# E3632A-04D

# S E R V I C E N O T E

## E3632A DC Power Supply

**Metal Strap Kit for tightening loose bumper and for fitting rear lock link in side-by-side rack mounting**

Figure 2: Top view 3mm gap observed between two different chassis designs

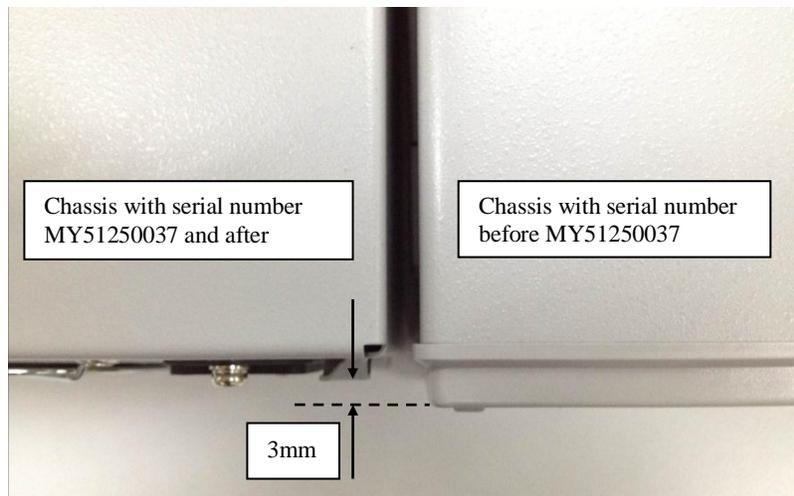
The chassis depth difference between the two designs is 3mm as shown in Table 1 and Figure 2 below.

Serial number range	Chassis depth
MY51250037 and after	345.2 mm
Before MY51250037	348.2 mm

Use metal strap (part number E3631-07901), and stack the provided two metal straps together to form 3mm thickness and secure it with the provided screws on the rear lock link as shown in Figure 5 below.

Figure 3: Top view 3mm gap observed on rear lock link for side-by-side rack mounting

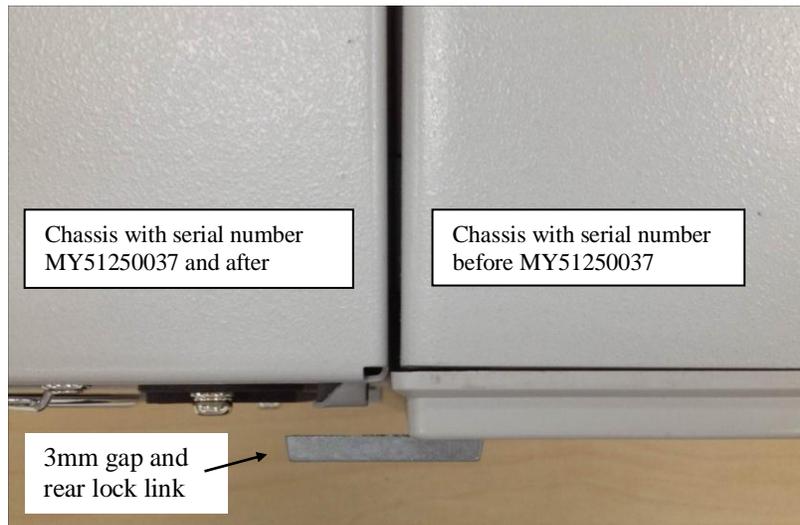
The 3 mm gap between the two different chassis may cause difficulties in securing them together using a rear lock link kit (part number 0050-2167) for side-by-side rack mounting as shown in Figure 3 below.
